Wisconsin Department of Transportation

Proposal #06: 3700-10-64

**La Crosse - Sparta
Medary Overpass B-32-111, B-32-115
STH 016
La Crosse County**

This is Addendum No. 01, which provides for the following:

Addendum No. 01
ID 3700-10-64
Revised Sheet 18
January 6, 2025

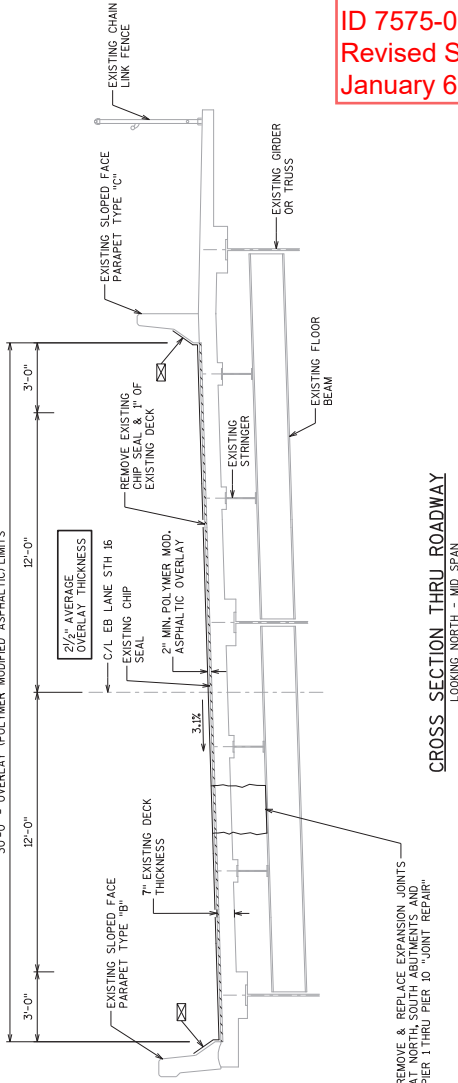
Revised Plan Sheets – 3700-10-64	
Plan Sheet	Plan Sheet Title (brief description of changes to sheet)
18	Miscellaneous Quantities (Revise locations of Concrete Bases Type 10-Special)

TOTAL ESTIMATED QUANTITIES - B-32-115

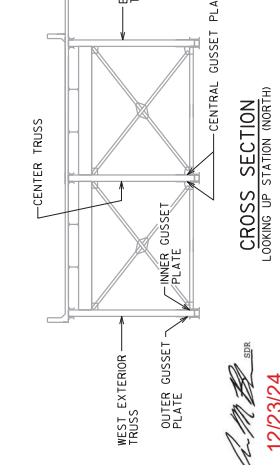
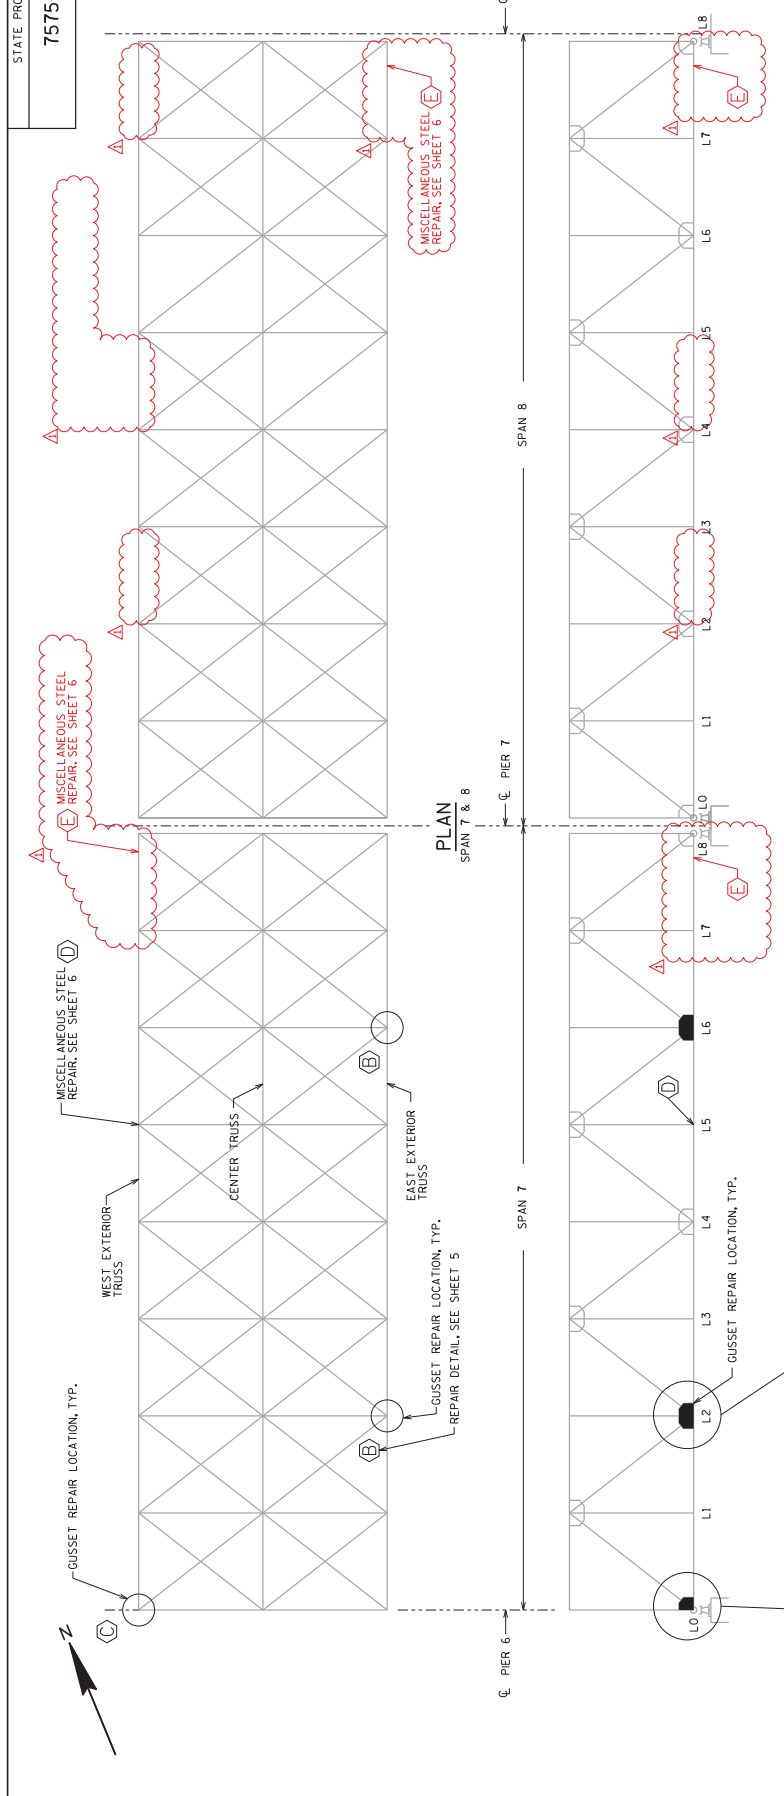
Revised Plan Sheets – ID 7575-01-65	
Plan Sheet	Plan Sheet Title (brief description of changes to sheet)
16	Structure B-32-115, Notes and quantities (Revise quantity of Bid Item 506.0105 Structural Steel Carbon in Total Estimated Quantities Table)
18	Structure B-32-115, Gusset Plate Repair 1 (Revise Miscellaneous Steel Repair callouts)
19	Structure B-32-115, Gusset Plate Repair 2 (Revise Miscellaneous Steel Repair callouts)
20	Structure B-32-115, Miscellaneous Steel Repair (Add note to Detail E Repair)

506.0305	STRUCTURAL STEEL CARBON	LB	1250
506.5000	BEARING ASSEMBLIES FIXED B-32-115	EACH	7
506.6000	BEARING ASSEMBLIES EXPANSION B-32-115	EACH	5
506.7050S	REMOVING BEARINGS B-32-115	EACH	12
